Service Bulletin

CBR650R #1
December 2025

SAFETY RECALL

2024 - 2025 CBR650R/RA WIRE HARNESS SHORT CIRCUIT

Locate the 8P Turn Signal Harness [1].

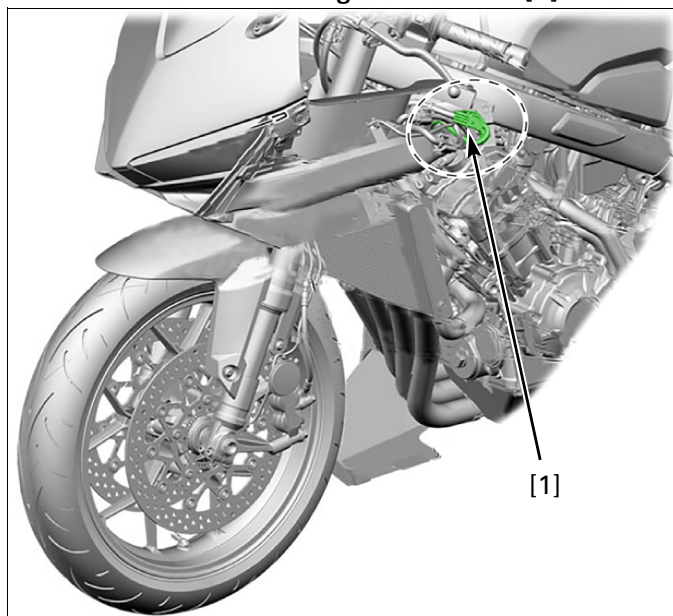
Reroute the 8P Turn Signal Harness using the steps below. You must ensure it is installed beneath the Sub Harness, and routed to the front side of the 4P Left Turn Signal Switch Harness.

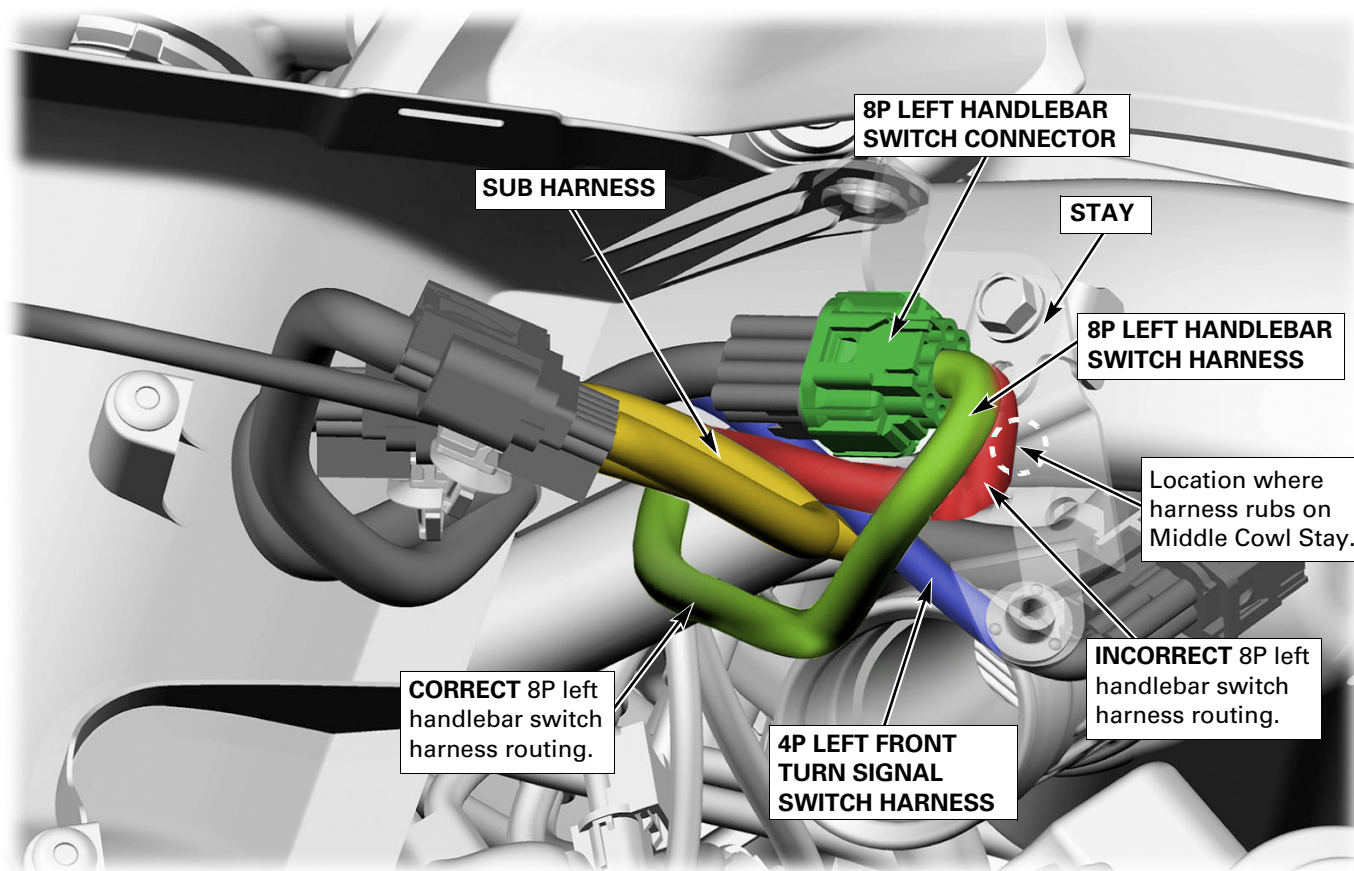
Perform an initial inspection on the 8P Turn Signal Harness (highlighted in green) to ensure there is ZERO damage on the harness near the middle cowl stay. Although unlikely on a new unit, if you notice wear or damage on a NEW unregistered unit, submit a *TechLine Connect*. See TECHLINE CONNECT - PHOTOGRAPH UPLOAD PROCEDURE on [page 5](#) for details.

1. Disconnect the 8P Left Handlebar Switch connector.
2. Route the 8P Left Handlebar Switch harness and connector (highlighted in green) underneath the front sub harness (highlighted in yellow).
3. Ensure the 8P Left Handlebar Switch harness and connector are routed in front of the 4P Left Front Turn Signal Switch Harness (highlighted in blue).
4. Slightly untwist and re-situate the Front Sub Harness, as demonstrated in the video link above.
5. Reconnect the 8P Left Handlebar Switch Harness connector.
6. Be sure the 8P Left Handlebar Switch harness does not contact the Left Middle Cowl stay.
